**FINAL
SUPPLEMENTAL ENVIRONMENTAL ASSESSMENT
SECTION 4(f) EVALUATION
PERRIS VALLEY LINE
RIVERSIDE COUNTY, CALIFORNIA**

FINAL SUPPLEMENTAL ENVIRONMENTAL ASSESSMENT

0.3 RESPONSE TO COMMENTS

FIGURE
0.2-1

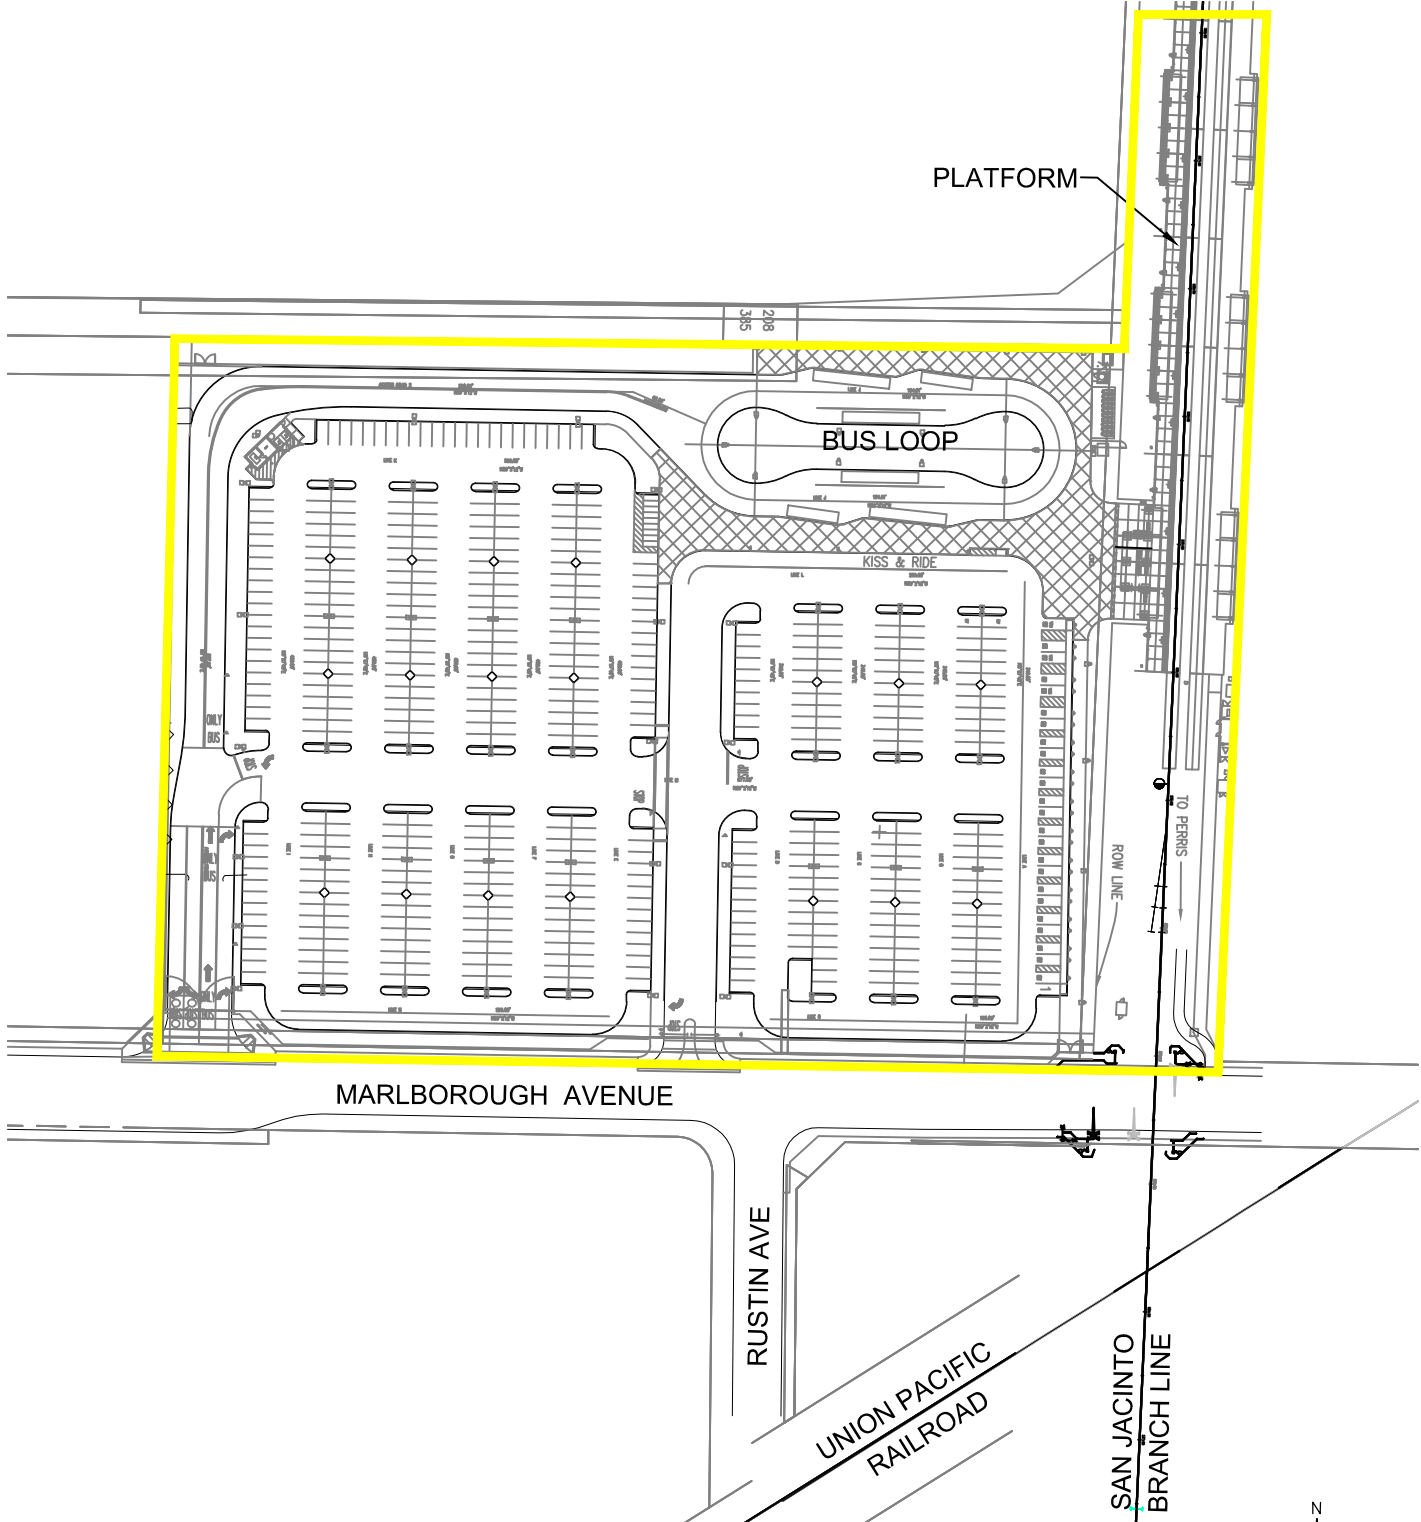
Three station sites were analyzed and considered for the Hunter Park Station in the SEA. The Palmyrita option was proposed for the east side of the SJBL track at Iowa Avenue between Palmyrita and Columbia Avenues. The Columbia and Marlborough options were proposed for the west side of the SJBL track, with entry and exit from Columbia and Marlborough Avenues, respectively. Each of the three options were evaluated in the SEA, subsequently, RCTC during the development of the Final SEA has selected the Marlborough site to be the Hunter Park Station.

The Marlborough site is located on cleared, disturbed vacant land. The current owner obtained approval of a development plan for multiple office buildings for the site from the City of Riverside. After a thorough review of the potential sites, while weighing the site access, engineering and cost considerations for all sites, the Marlborough site has been identified as the most suitable site location for the Hunter Park Station.
